OCT 19-21 MTG SUMMARY

The purpose of this letter is to transmit the meeting summary for the October 19-21, 1988 NRC-DOE meeting on the Exploratory Shaft Facility. Representatives from the State of Nevada, Nye County, Nevada, Utility Nuclear Waste Management Group, and General Accounting Office also attended and participated.

SUMMARY OF DOE-NRC MEETING ON ESF OPEN ITEMS
 October 19-21, 1988
 DOE Forrestal Bldg., Washington, D.C.

Figure 3. Comparative Illustration of the Final EA Versus the Proposed Exploratory Shaft Locations

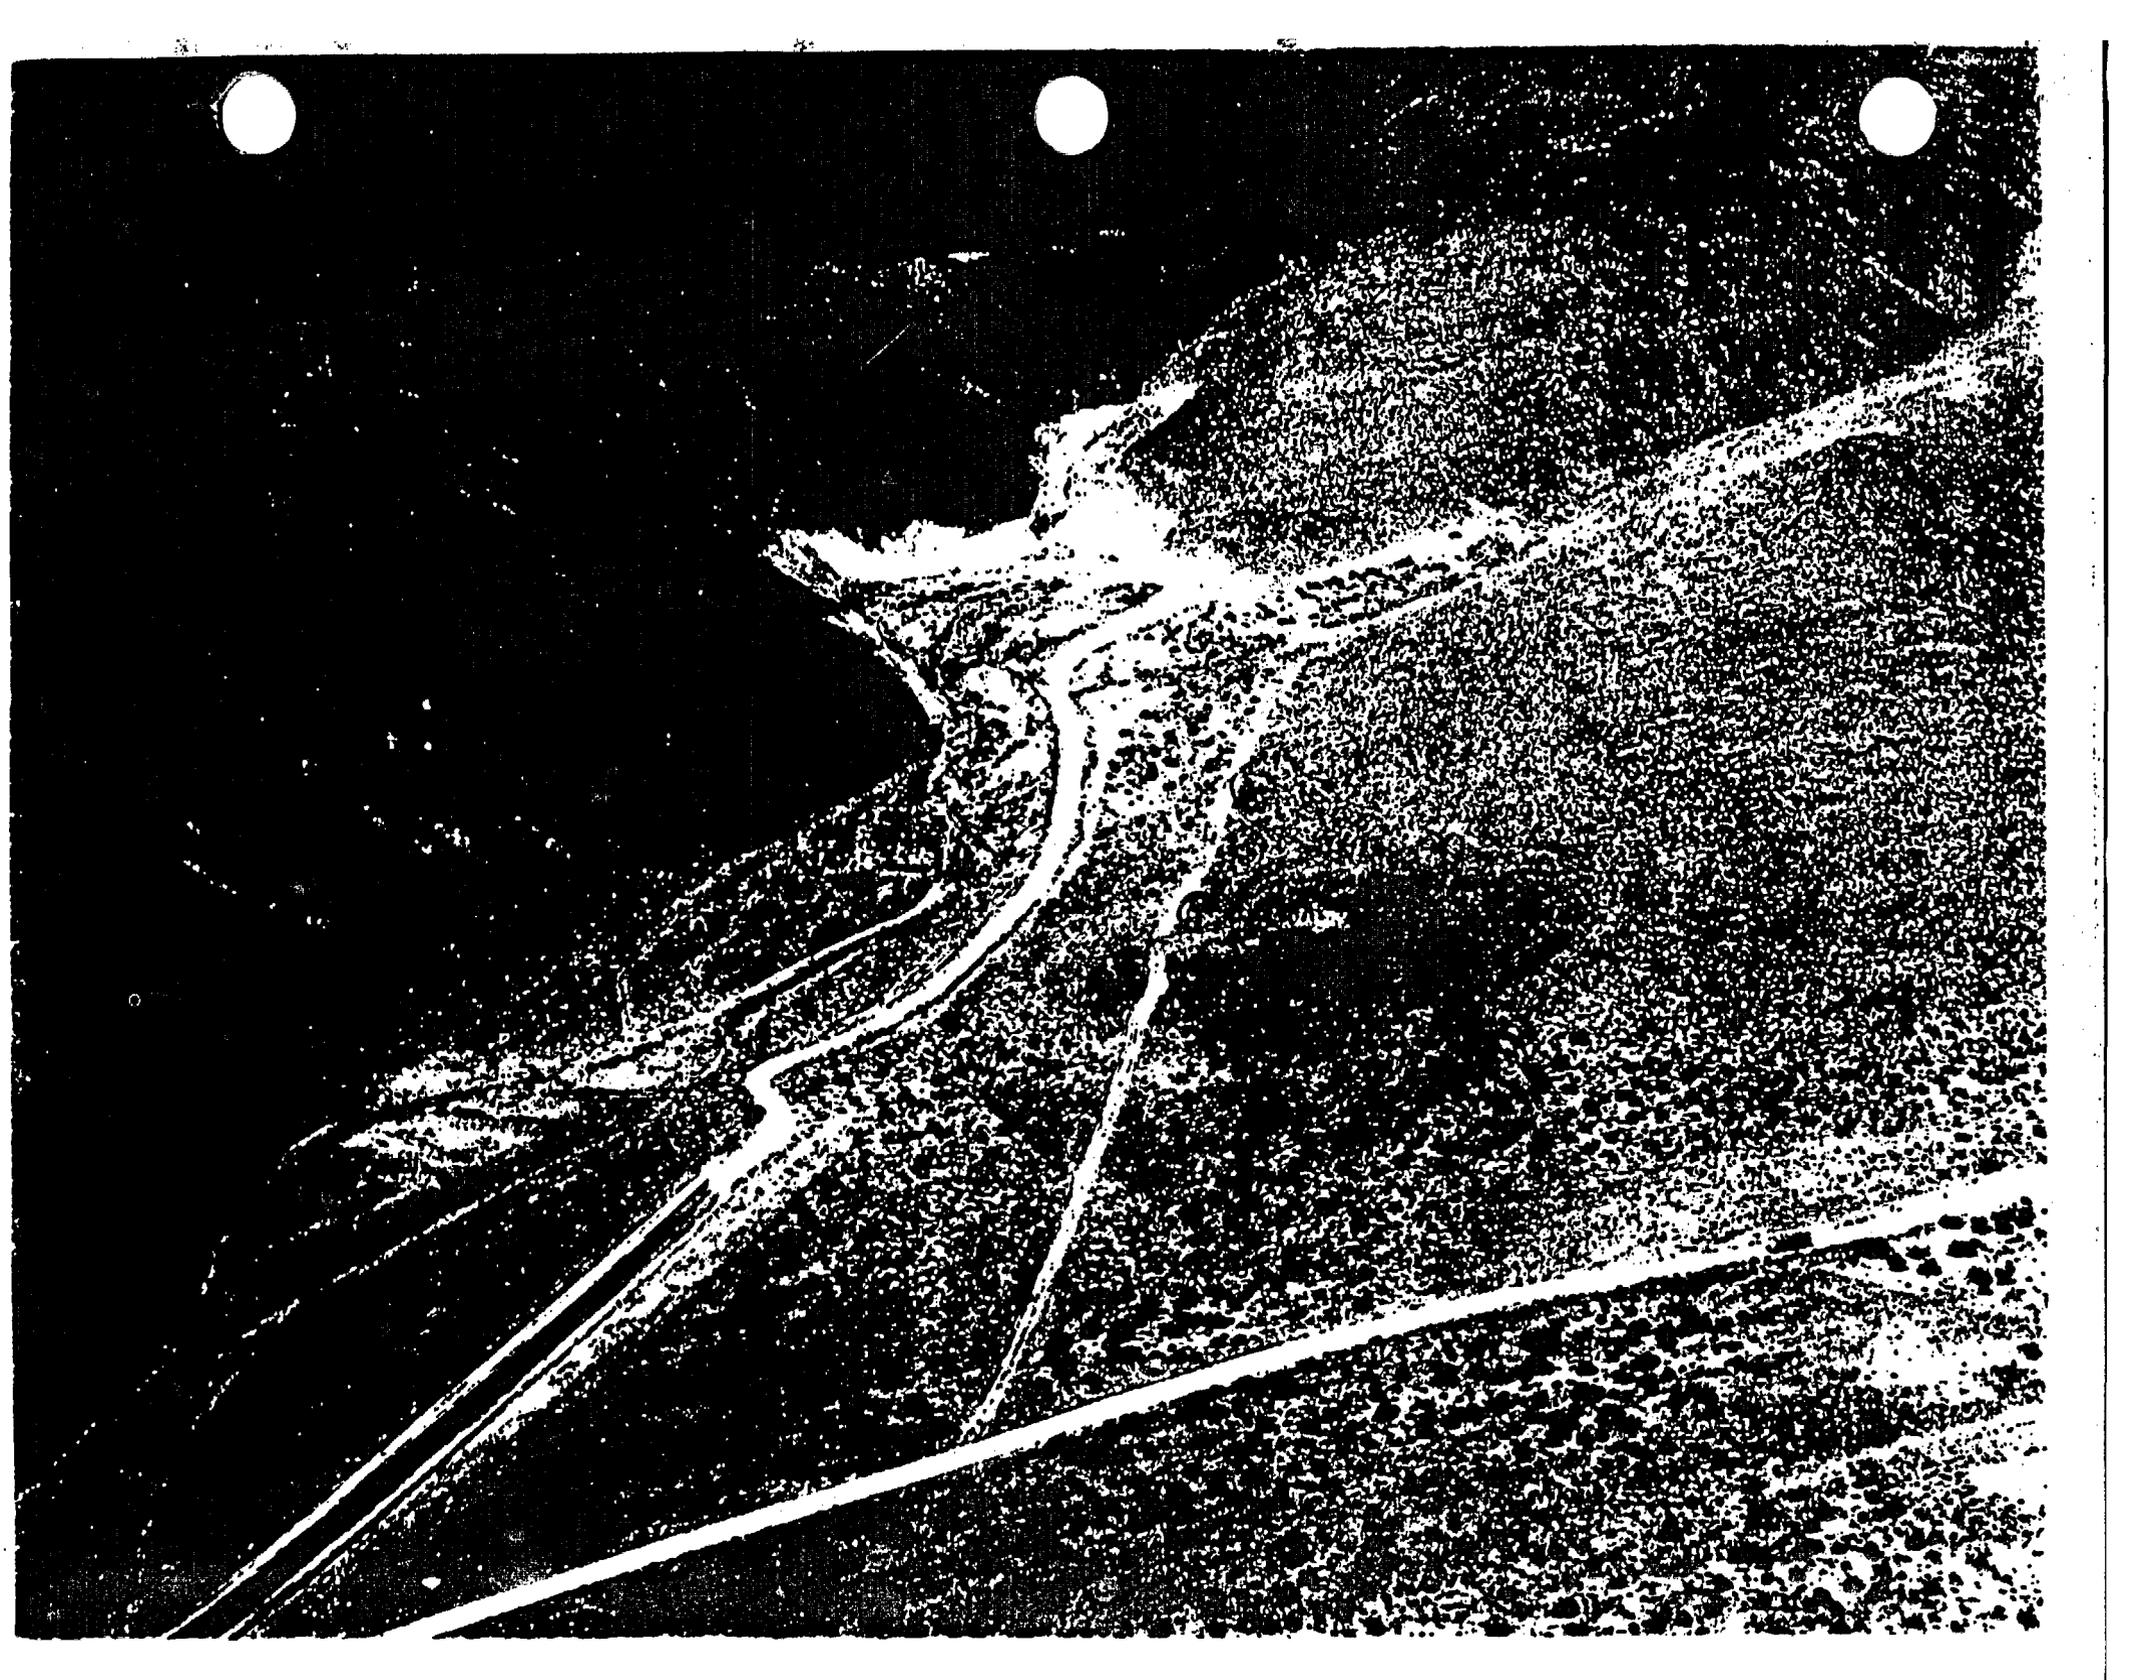
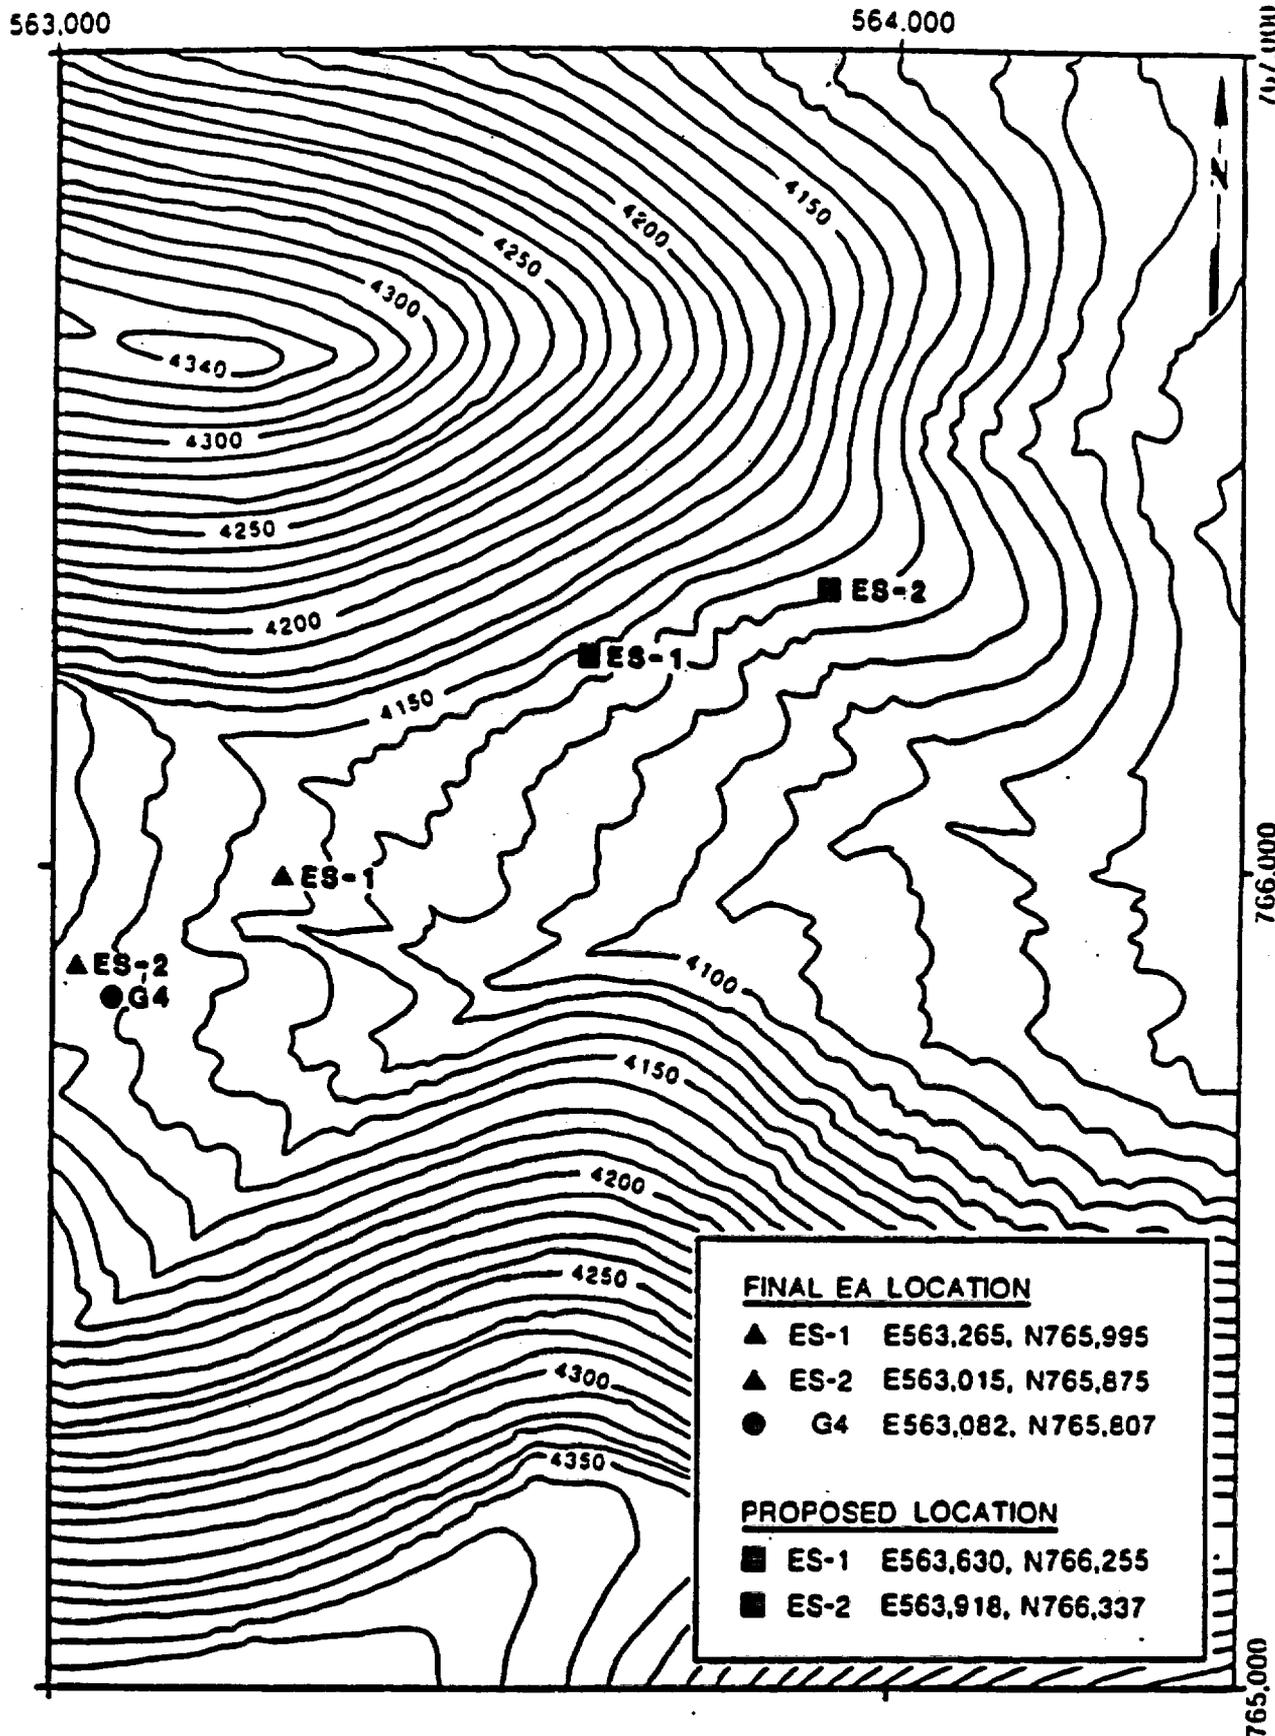
THE SHAFT LOCATIONS DECISION PROCESS SHOULD DEMONSTRATE THAT "PARTICULAR ATTENTION (WAS GIVEN) TO THE ALTERNATIVES THAT WOULD PROVIDE LONGER RADIONUCLIDE CONTAINMENT AND ISOLATION."

DOE SHOULD PROVIDE DOCUMENTATION OF THE DESIGN CONTROL PROCESS FOR ESTABLISHING TIE BETWEEN SDRD REQUIREMENTS AND 10 CFR 60 REQUIREMENTS GOVERNING SHAFT LOCATIONS.

- * IMPLEMENTATION OF 10 CFR 60 REQUIREMENTS IN THE SHAFT LOCATION SELECTION PROCESS, INCLUDING USE OF QUALIFIED DATA
- * CONSIDERATION OF INTERFACES BETWEEN SHAFT LOCATIONS, UNDERGROUND TEST AREA, AND REPOSITORY DESIGN, INCLUDING INTERFACES AMONG PARTICIPATING DESIGN ORGANIZATIONS
- * VERIFICATION OF ADEQUACY OF SHAFT LOCATIONS AND ESF/REPOSITORY DESIGN INTERFACES
- * EVIDENCE OF ADEQUATE DESIGN CONTROL PROCESS FOR THE DECISION TO CHANGE SHAFT LOCATIONS IN APRIL '87
